4
5 AN ORDINANCE approving Change
6 Order No. 10 in connection
with Division II for WPC Plant
Expansion.

PROJECT Terminal Ponds OWNER City of Fort Wayne, Indiana

CHANGE ORDER NO. 10

PROJECT Division II - Terminal Ponds - Fort Wayne, Indiana

CITY OF FORT WAYNE, IND
WATER QUALITY CONTROL PROJECT, DIV. II
STORM WATER OVERFLOW DITCH

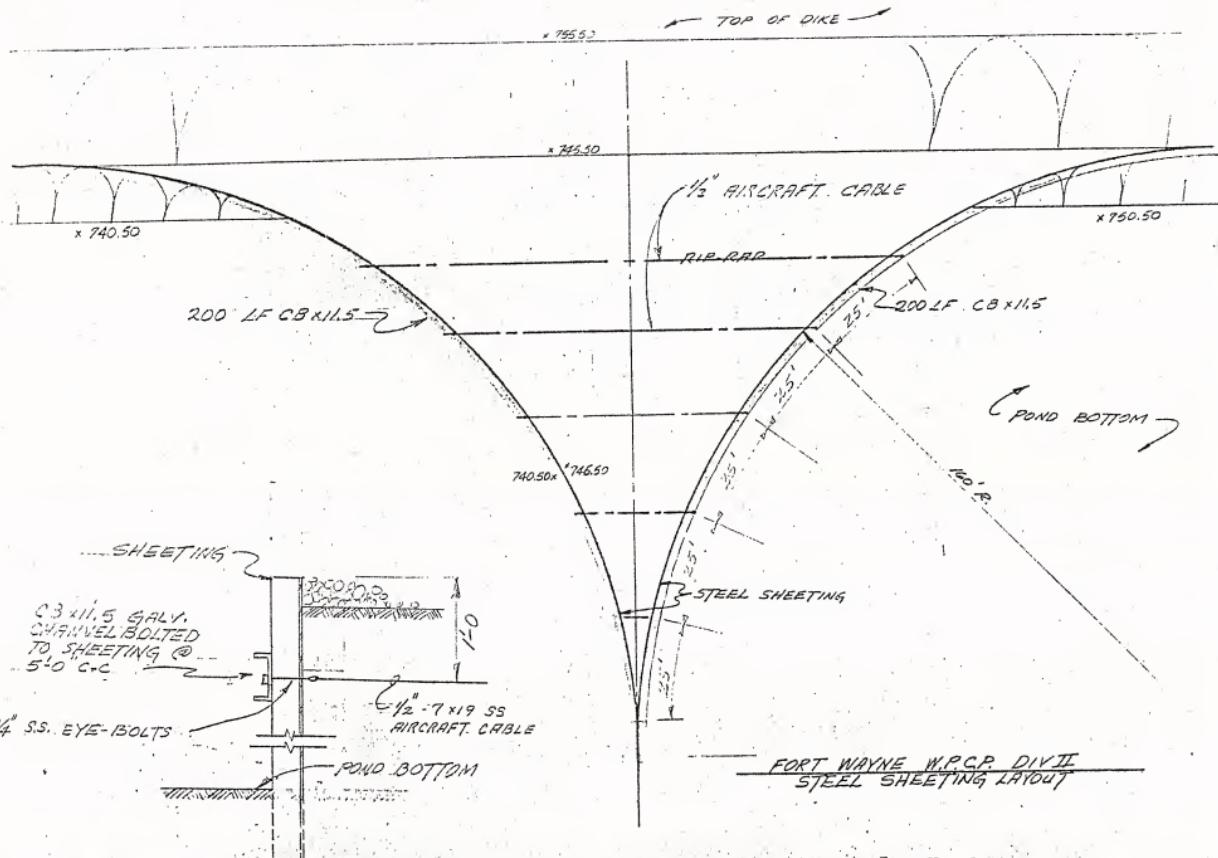
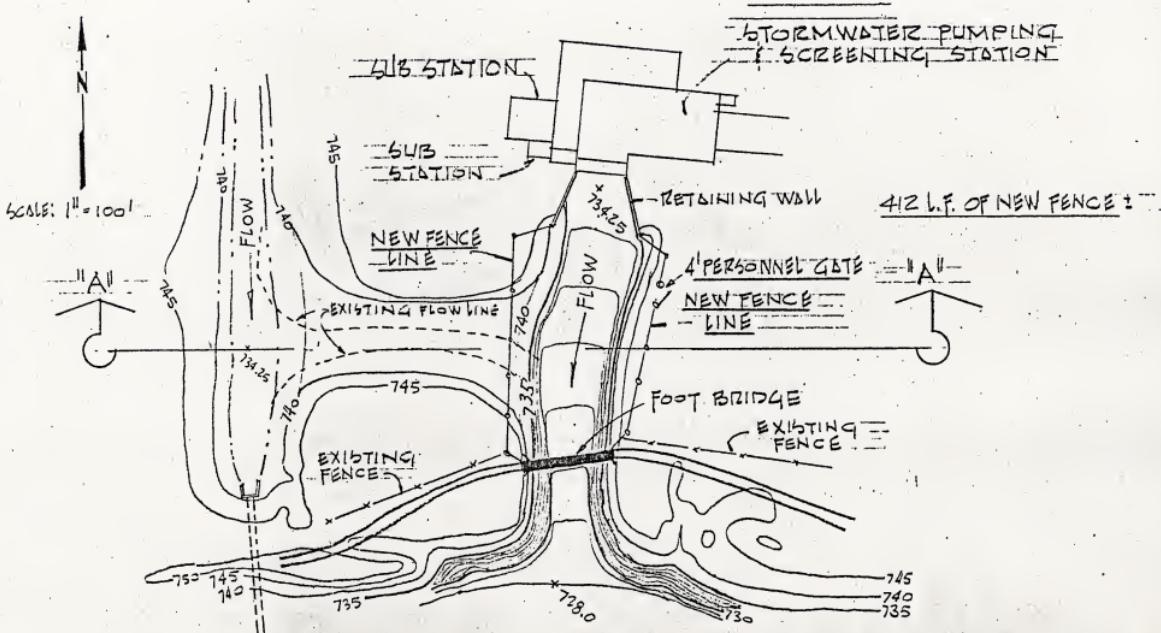
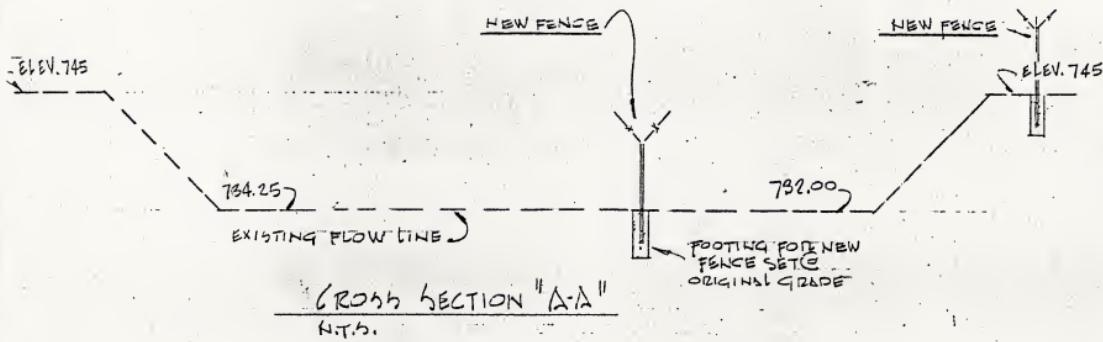
<u>Item No. 8</u>		
Furnish all labor and material necessary to construct a new security fence around the new stormwater overflow ditch. Approximately 420 L.F. of new 8' high chain link fencing will be required. See attached drawings for location.	3,646.50

1. Necessity for change: The installation of the additional security fencing is being proposed to increase the security of the stormwater facility. During dry weather, the channel will be dry and permitting people and stray animals to enter the facility through the open ditch. With the installation of the fencing along each side of the channel such access will be removed.
